Questions regarding the GoldSim HTF Alternative Fast Zone (AFZ) Simulations
(Responses are provided in red text)

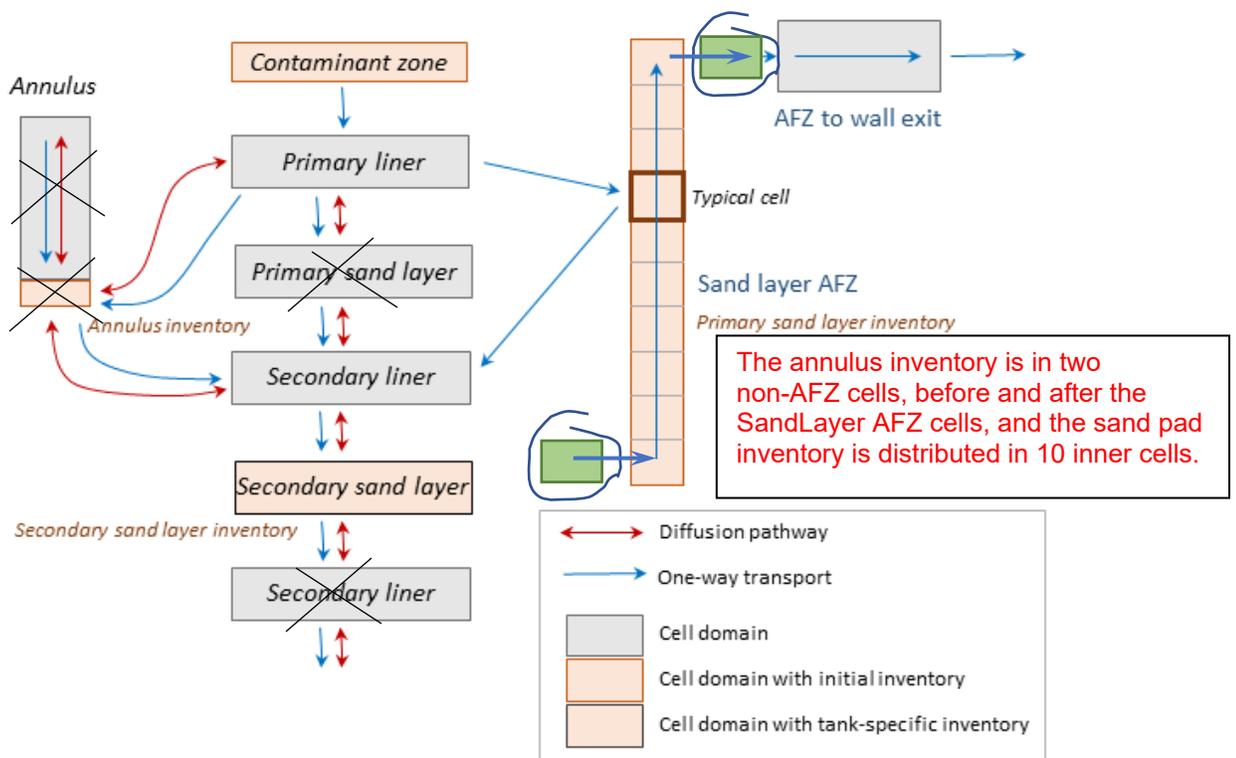
- For Type I tanks with a shrinkage crack AFZ.
 - The GoldSim model appears to load all annulus inventory into the AFZ cells. Please confirm that this understanding is correct or describe the correct model.

- The annulus model appears to represent radial diffusion from the primary liner to the AFZ cells using AnnulusBottom_AFZ (which appears to also initially have all of the annulus inventory). Please confirm that this understanding is correct or describe the correct model.

- Each cell in the annulus model appears to receive flow from the primary liner cell and lose the same flow to the secondary liner cell. Please confirm that this understanding is correct or describe the correct model. If this is the correct understanding, please explain the rationale for applying flow passing from the tank to annulus cells.

- For Type II tanks
 - The GoldSim model appears to load all primary sand layer inventory into the AFZ cells. Please confirm that this understanding is correct or describe the correct model.

- The GoldSim model appears to load all secondary sand layer inventory into the secondary sand layer cell. Please confirm that this understanding is correct or describe the correct model.

- The annulus representation appears to consist of the AnnulusModel and AnnulusBottom_ctn (which initially has none of the annulus inventory set because of the switch noAFZ). Also, what does ctn stand for?

- The “AnnulusBottom” represents the base of the annulus grout. The inventory is loaded in the grout and not in the AFZ crack.
 - There are 5 radial cells, which allow primary inventory to diffuse outwards.

- The AFZ is between the outer radial shell of the annulus bottom and the inner perimeter of the vertical wall of the secondary liner. The AFZ allows clean water to flow from a joint at the upgradient cell and contaminated water to flow out from a joint at the downgradient cell.

- There are different options for running the AFZ case. For example, AFZ option 2 zeros out the inventory. AFZ option 4 allows radial diffusion between the annulus bottom and the AFZ.

- The sand pads are turned off for Type I tanks (no grout pad between the primary and secondary liners is simulated) and so the vertical flow downwards is through the primary liner and then to the secondary liner.

- The annulus is not activated in the AFZ case (the set of cells to the left in the lower portion of the figure below for Type II tanks is not activated).

- The primary sand pad is not activated in Type II tanks for the AFZ case.
 - The part of the AFZ representing the primary sand pad consists of 10 cells under the primary liner.

- The part of the AFZ representing the annulus is represented by two cells, one upstream of the first primary sand pad AFZ cell and one downstream of the last primary sand pad AFZ cell.

- The annulus inventory is located in the two AFZ cells representing the annulus, and the sand pad inventory is loaded in the inner sand layer AFZ cells (10 inner cells).

- There is no diffusive path from the primary waste to the sand layer AFZ cells (there is only advection). This is different from the Type I tanks which allow diffusion of waste from the primary to the sand layer AFZ cells. Department of Energy (DOE) contractors indicate that numerical dispersion accounts for any diffusion from the primary liner to the sand layer AFZ.
